Docket No. 50-423  
B13800

Attachment 1  
Millstone Nuclear Power Station, Unit No. 3  
Proposed Technical Specification Change  
Hydrogen Recombiners

April 1991

FIGURE 3.6-2  
HYDROGEN RECOMBINER ACCEPTANCE CRITERIA  
FLOW VS CONTAINMENT PRESSURE \*

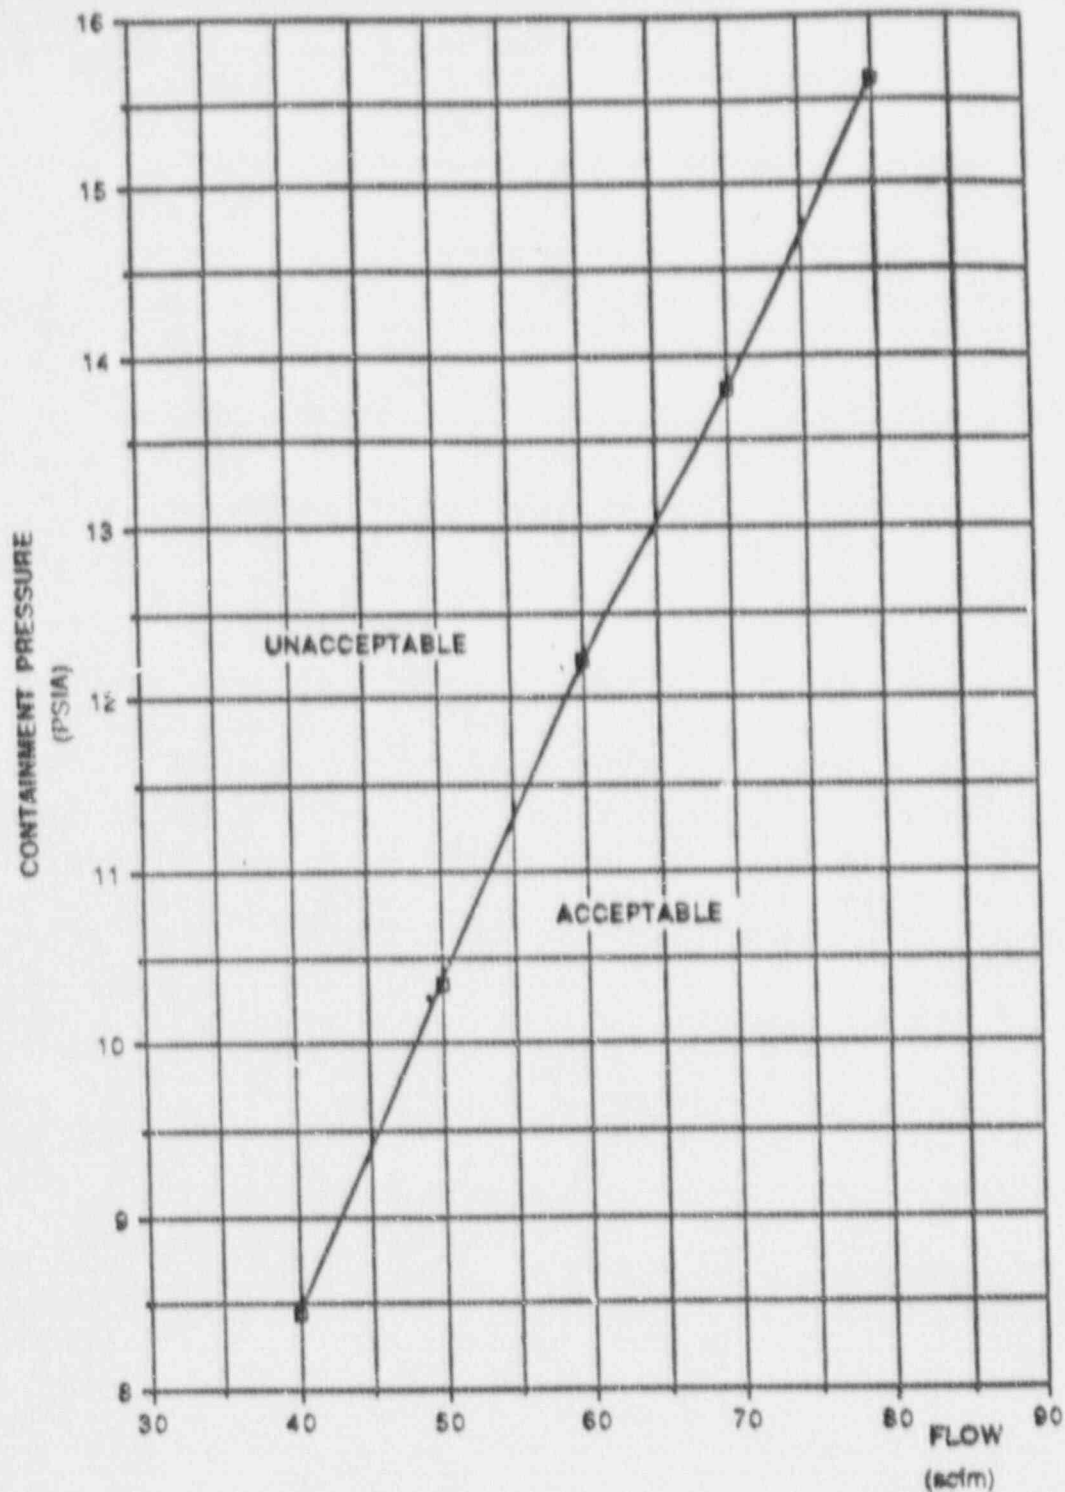
\*Until September 30, 1991, a flow rate of 72.4 scfm or greater at a pressure of 14.5 to 14.8 psia is acceptable in lieu of the values indicated by Figure 3.6-2.
